## --- ADDENDUM #3 ---

Issued September 3, 2024 to all bidders

# Wolfville AT Connection

CLIENT  
PROJECT DESCRIPTION  
**WOLFVILLE AT CONNECTION**  
WOLFVILLE, NOVA SCOTIA  
SHEET DESCRIPTION

RAISED CROSSWALK AT HABOURSIDE DRIVE  
SCALE: 1:100

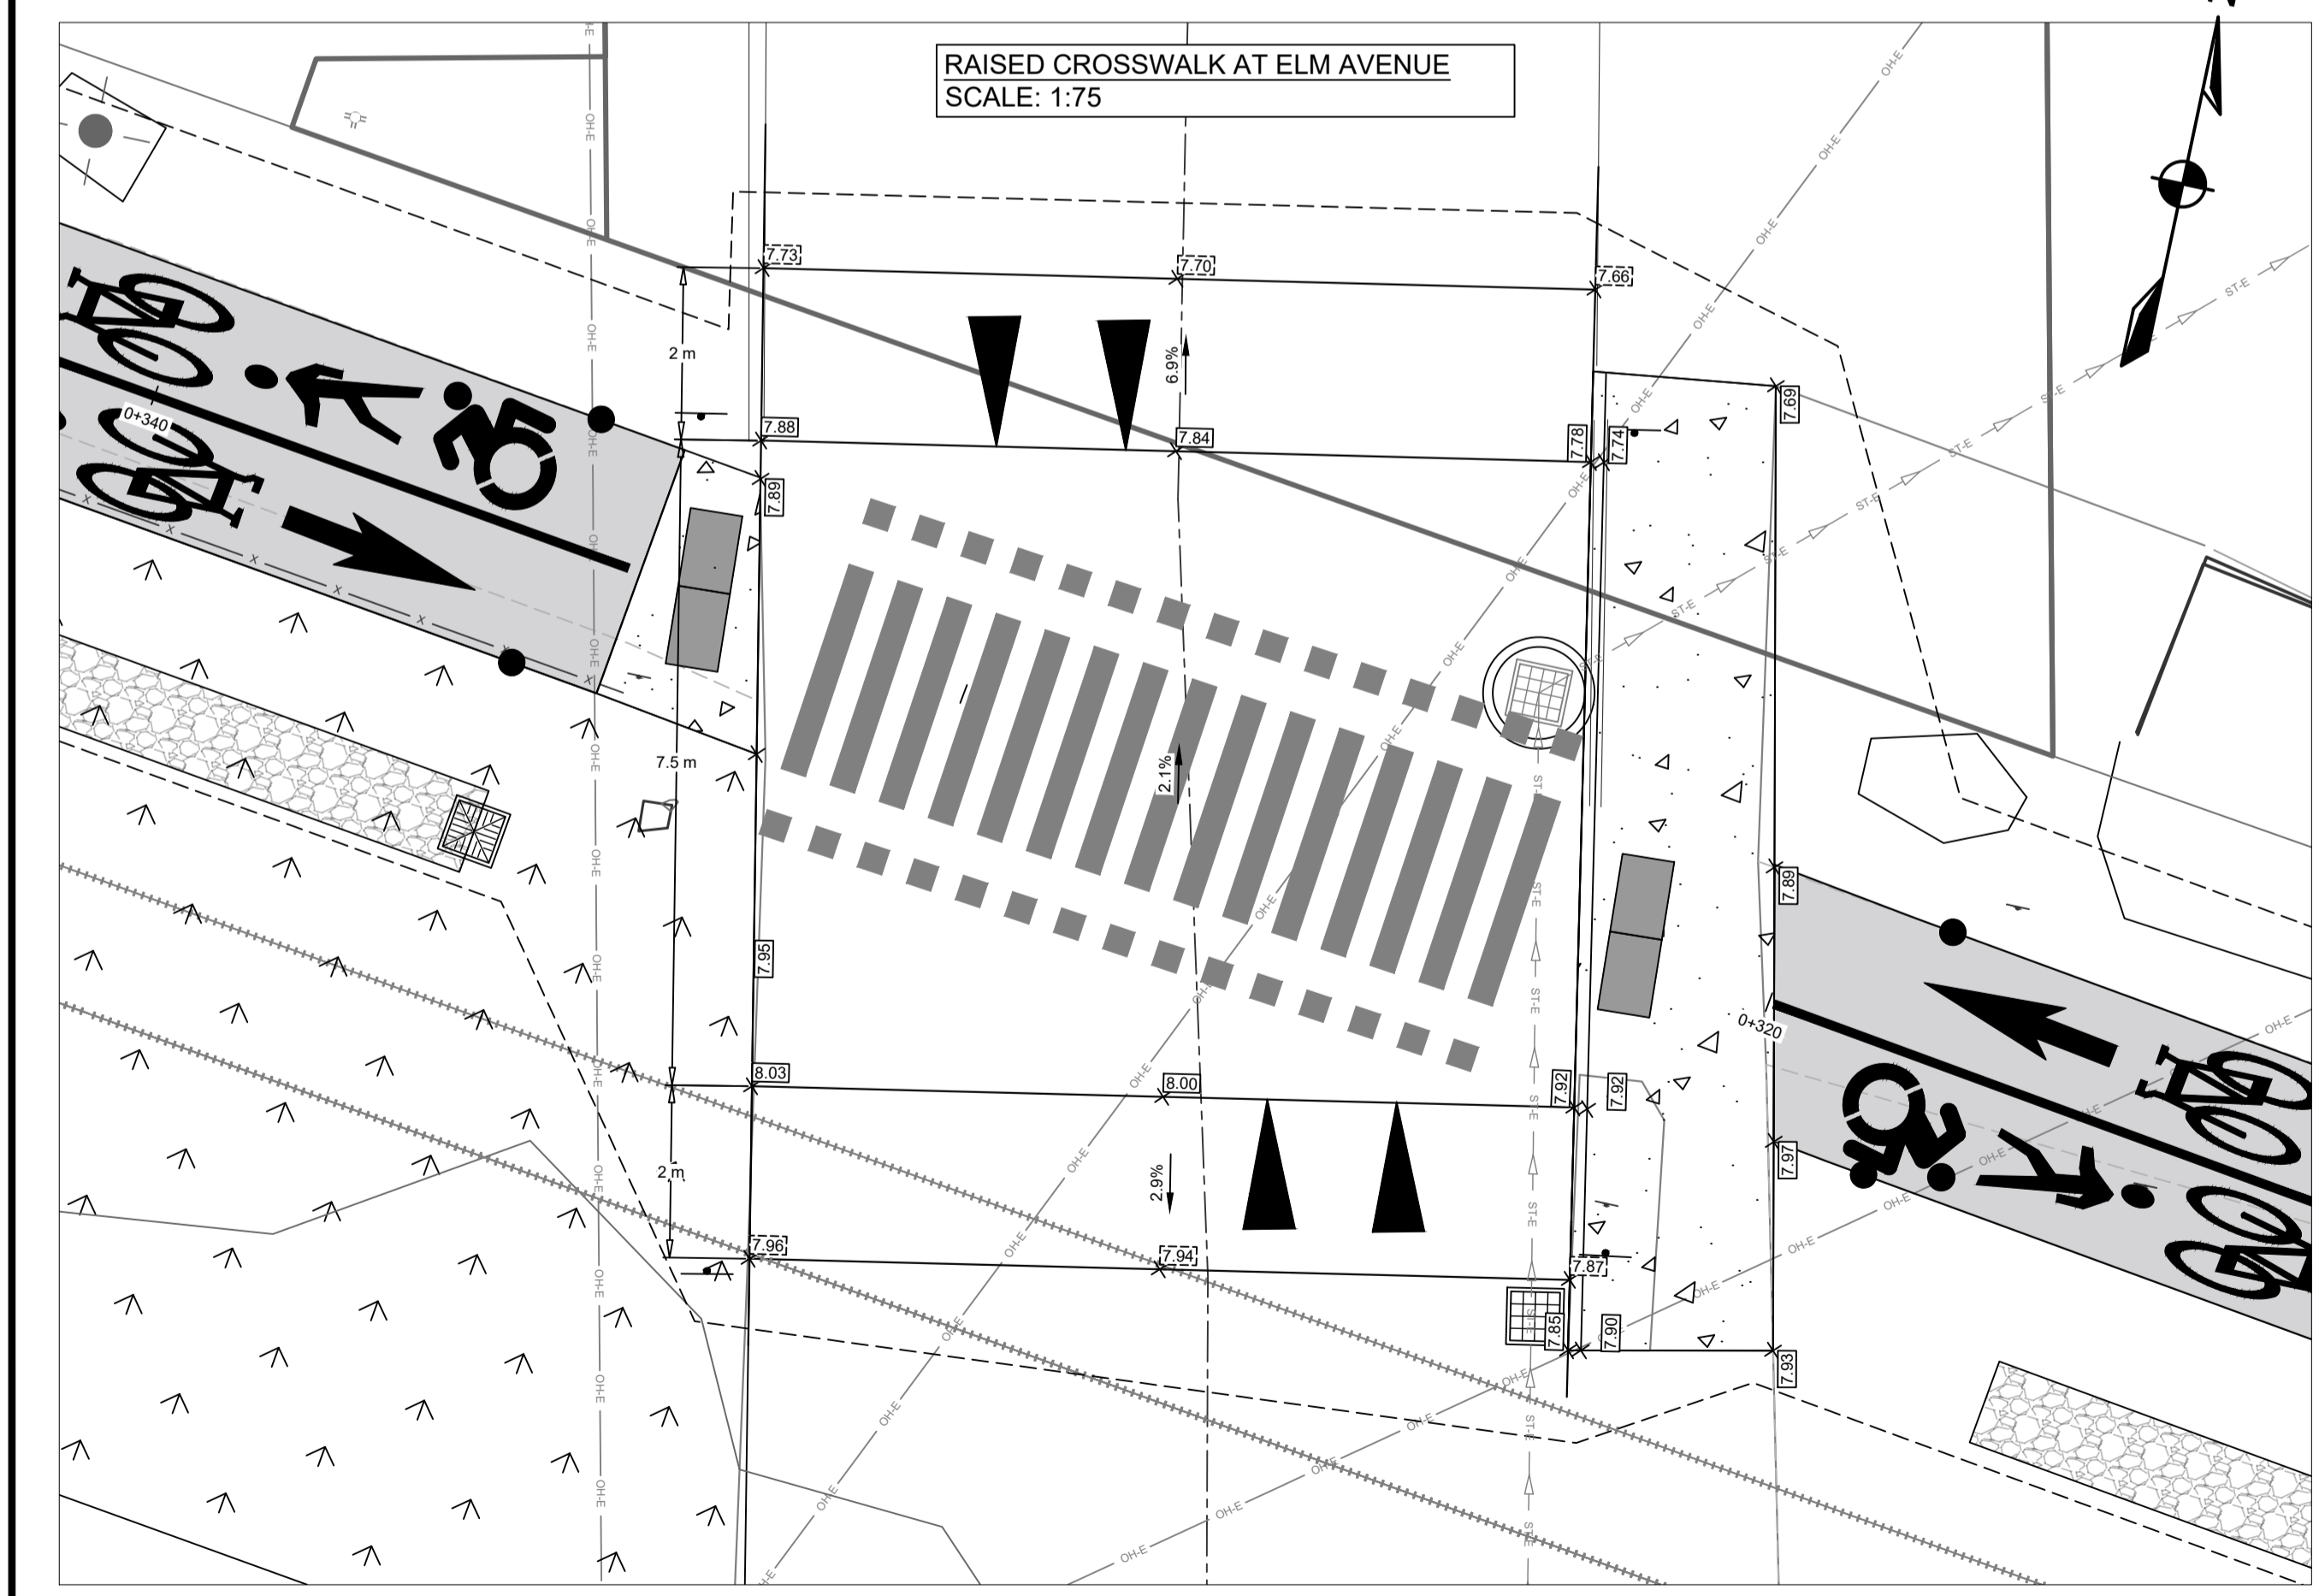
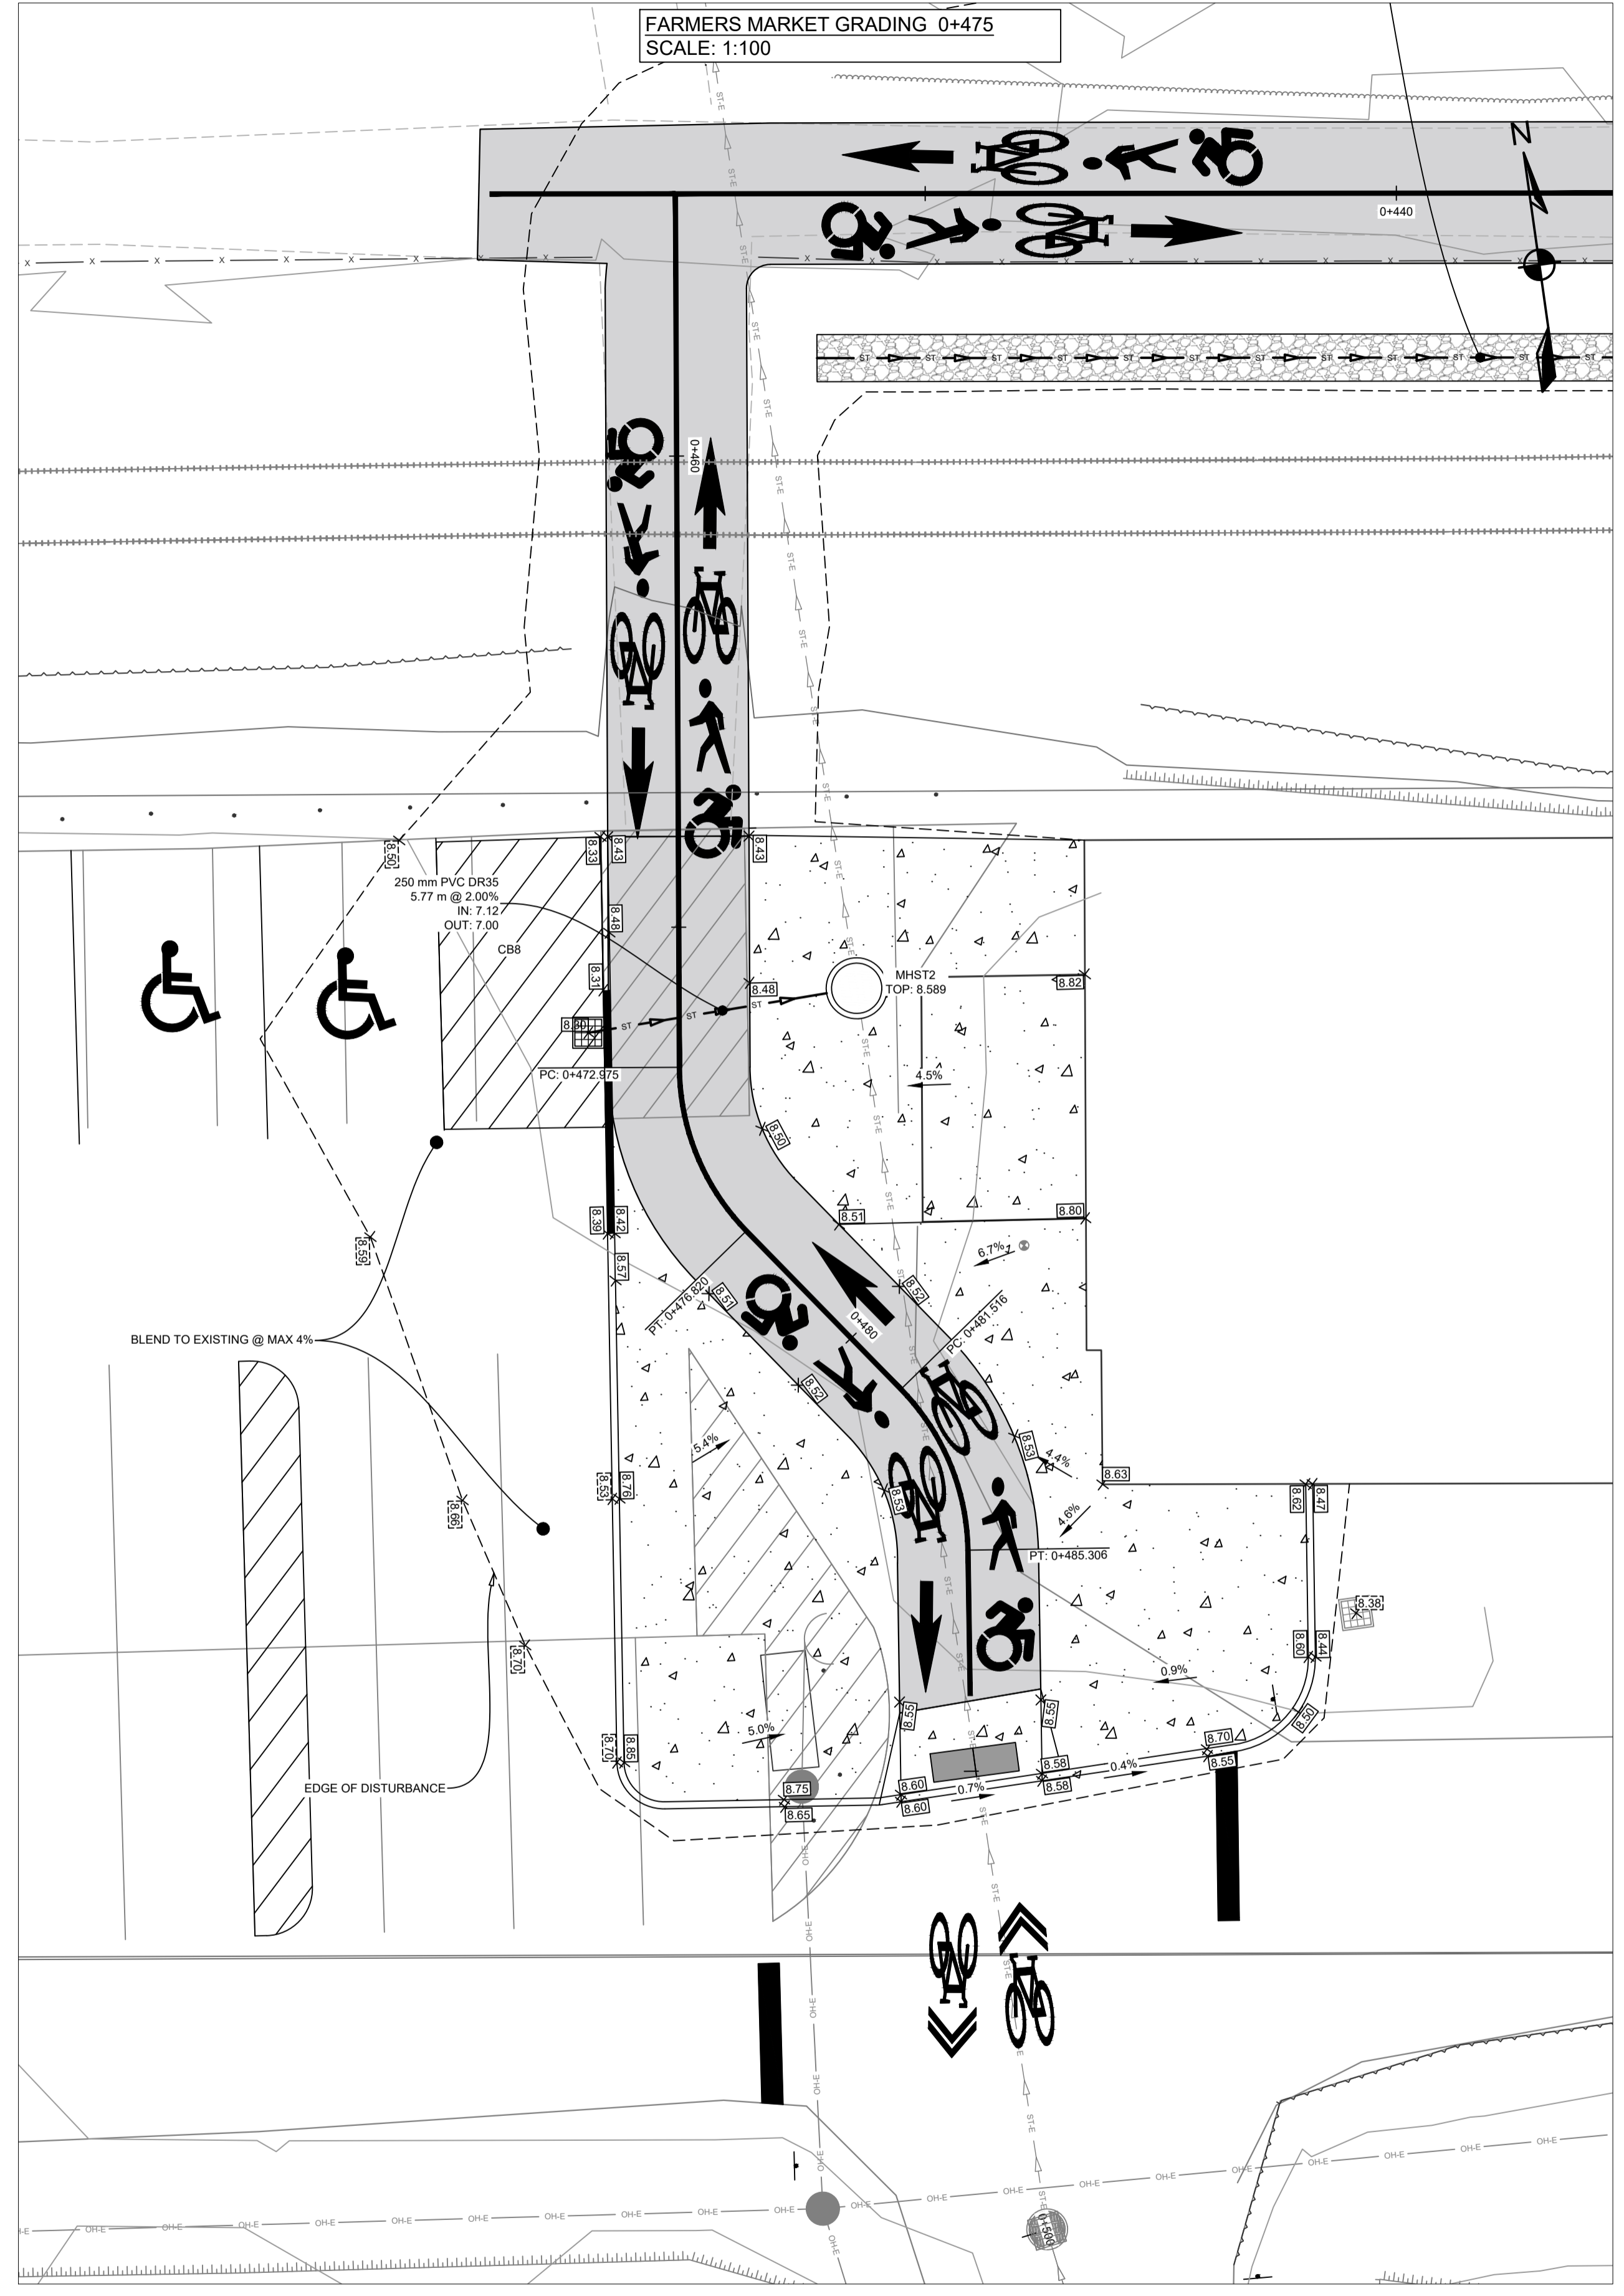
.8 There is no detail provided for the raised crosswalks, speed humps, Or RRFB. Please provide a detail for the raised crosswalks, speed humps, and RRFB? Details showing requirements for the RRFB will need to be provided as the requirements vary as does the pricing. RRFB's can cost anywhere from \$2,500 to \$6,500. Where the raised crosswalks are required, please confirm these can be constructed on top of the existing asphalt?

- a. **Drawings have been updated to note that the raised crosswalks on Harbourside Drive and Elm Street are to be completed as per HRM 196 (as modified by TOW standard detail R-111), RRFB and raised crosswalk on Main Street to be constructed as per HRM standard details HRM 172 and HRM 196 (as modified by R-111). All of these details are attached as part of addendum.**

### TRENCH AND BACKFILL CROSS SECTIONS

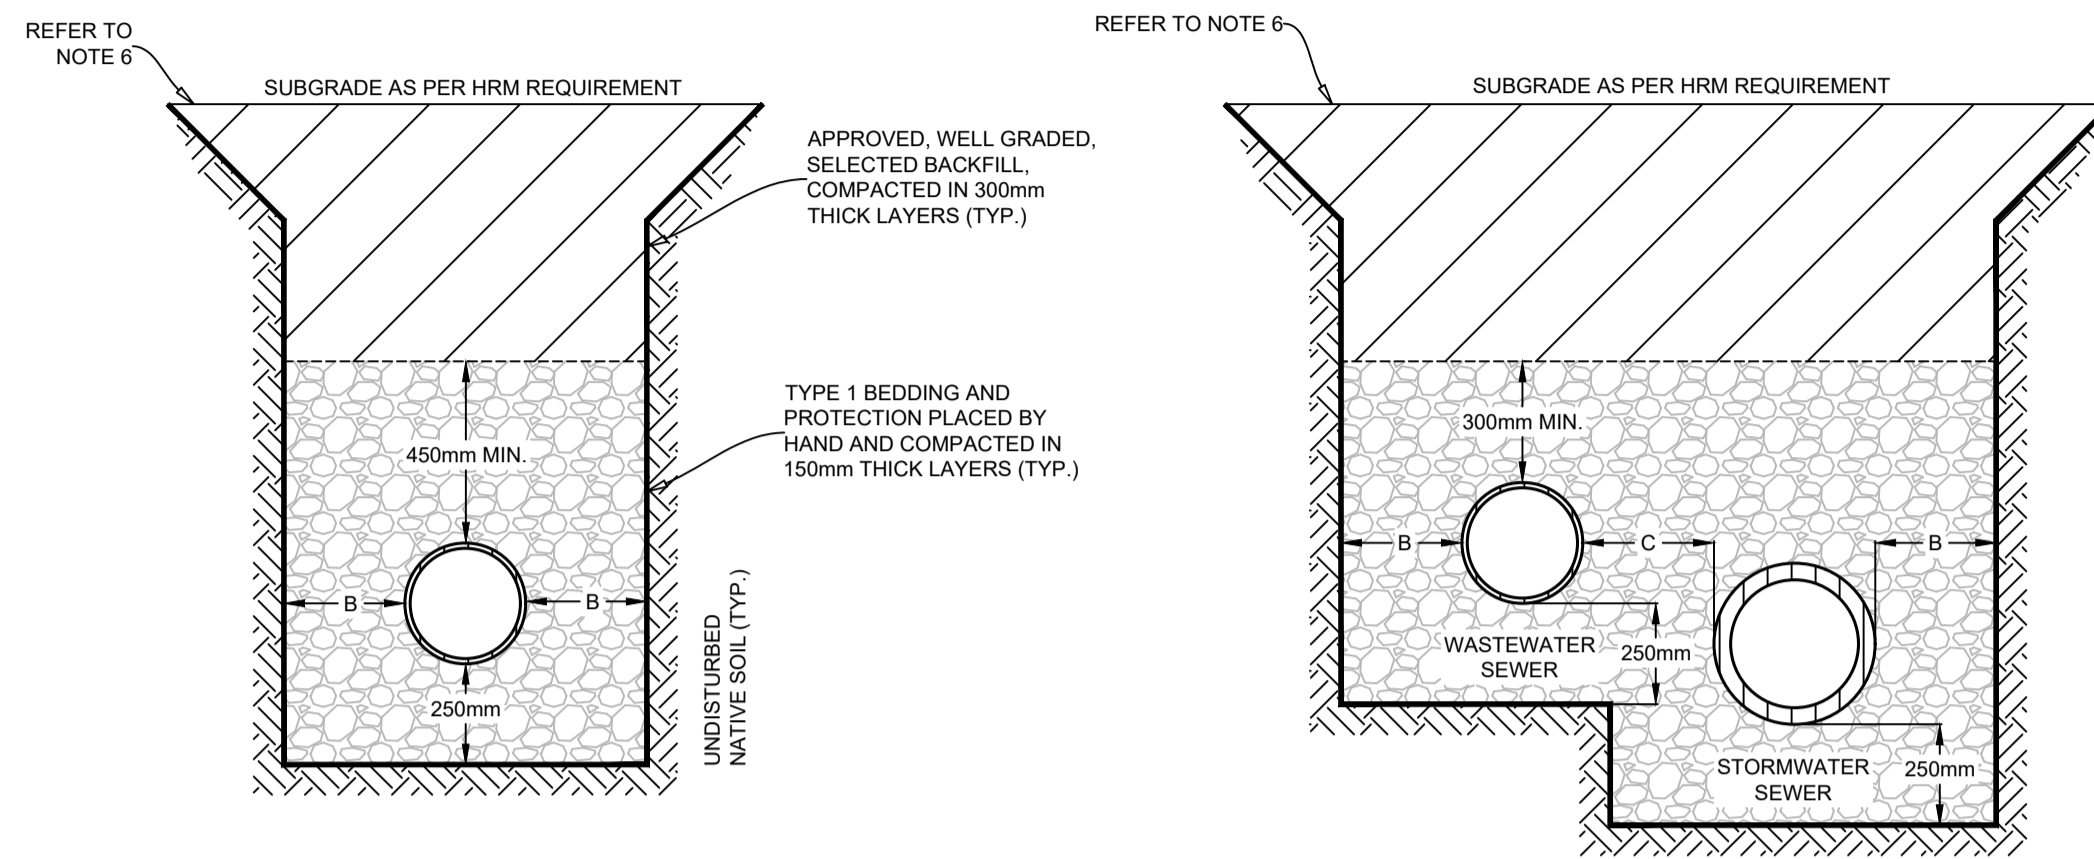
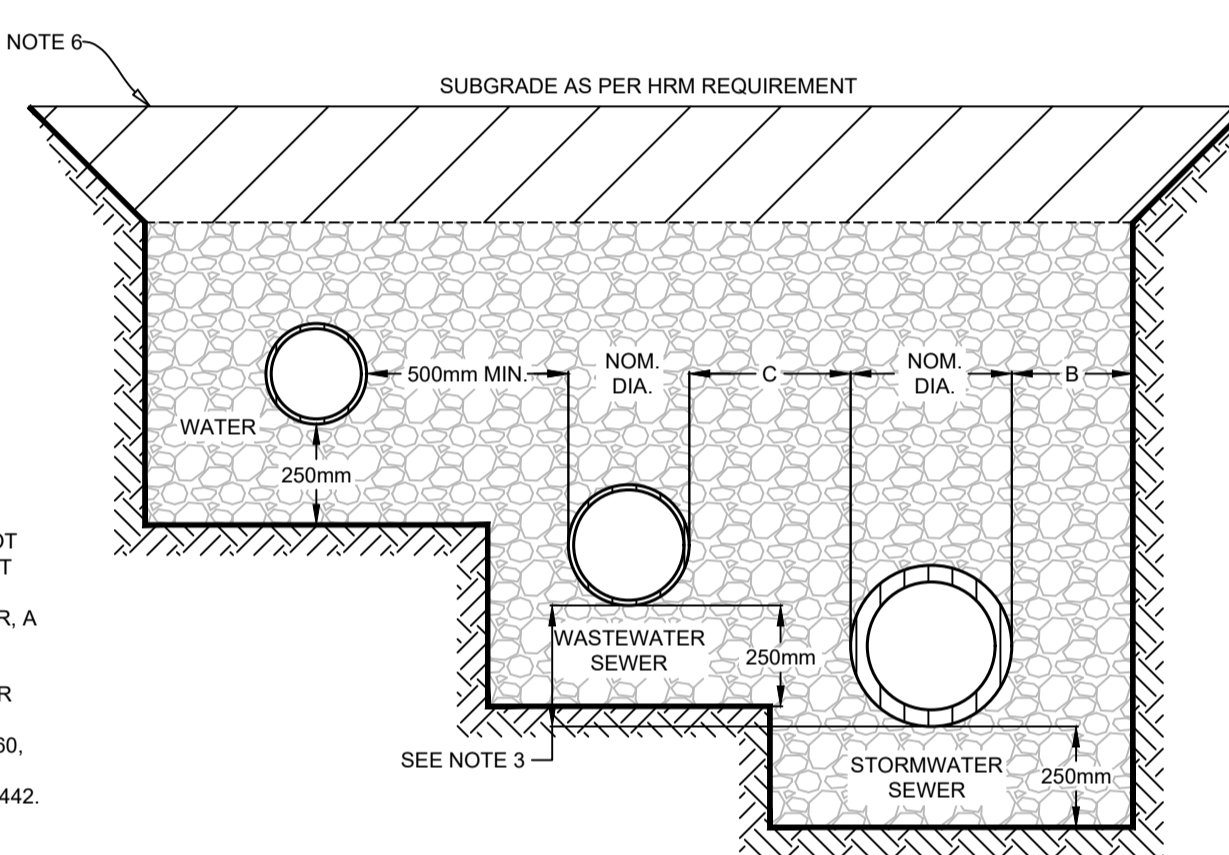
.19 There is no detail for the new pipe. Please provide a pipe detail showing the required thicknesses of bedding material?

**a. A detail has been added to the design drawings.**
